Project	IEEE 802.16 Broadband Wireless Access Working Group < <a href="http://ieee802.org/16">http://ieee802.org/16</a> >	
Title	MRS Paging Group Update Remedy	
Date Submitted	2007-03- <del>13</del> 14	
Source(s)	<p>John Lee, Yan Peng, Zheng Shang, Bin Xia</p> <p>Huawei Technologies No.98, Lane91, Eshan Road, Shanghai, P.R.C</p> <p><u><a href="#">Shashikant Maheshwari , Haihong Zheng, Yousuf Saifullah</a></u> <u><a href="#">Nokia</a></u> <u><a href="#">6000 Connection Drive, Irving, TX, USA</a></u></p>	<p>Voice: 86-21-5099-3164 <a href="mailto:John_lee@huawei.com">[mailto: John_lee@huawei.com]</a></p> <p><u><a href="#">Voice: +1 972 894 5000</a></u> <u><a href="mailto:Haihong.1.Zheng@nokia.com">Haihong.1.Zheng@nokia.com,</a></u> <u><a href="mailto:Yousuf.Saifullah@nokia.com">Yousuf.Saifullah@nokia.com,</a></u> <u><a href="mailto:Shashikant.Maheshwari@nokia.com">Shashikant.Maheshwari@nokia.com</a></u></p>

IEEE C802.16j-07/261r1

# MRS Paging Group Update Remedy

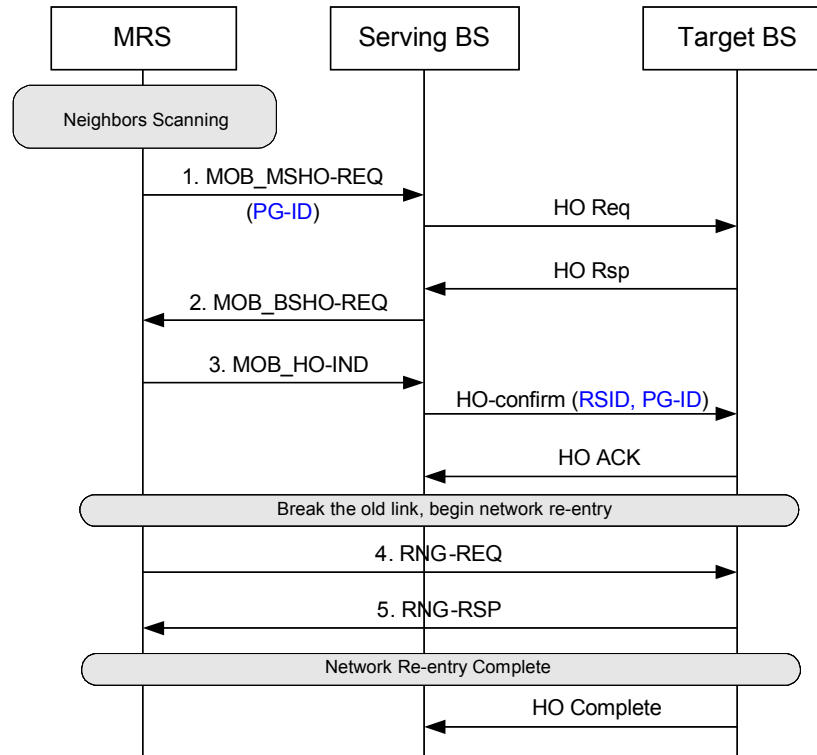
The following figure shows the procedure of MRS updating the paging group information. The serving BS communicates with target BS through backbone network, and the corresponding procedure and messages are

defined in WiMAX Stage 3 document. [Modifications are shown in BLUE.](#)

When MRS enters into the coverage of a new BS and decides to make handover, [if it find it's necessary to update paging group in Target BS](#), it will send the serving BS MOB\_MSHO-REQ message with ~~Mode parameter which requests serving BS to transfer the RS PG\_ID to the target. If needed, the MOB\_HO-REQ maybe contains~~ RS PG-ID parameter [which requests serving BS to transfer the RS PG\\_ID to the target](#). After HO-Req/HO-Rsp message exchange with the target BS, the Serving BS responds with MOB\_BSHO-RSP message. The MRS uses MOB\_HO-IND to commit handover. Upon receipt of MOB\_HO-IND, the serving BS sends HO-confirm (including RS ID and RS PG\_ID), which inform the target BS to add the RS PG-ID to its PG\_ID list.

The target BS updates its PG\_ID list using RS PG-ID in HO-confirm message. And the target BS would also notify other network entity e.g. ASN-GW/PC about the location of MRS.

The previous BS [may](#) also [remove](#) the RS PG\_ID from its PG list when it receives HO Complete message from the target. Possibly the serving BS sets a timer upon receiving MOB\_HO-IND, and deletes the RS PG-ID when the timer expires.
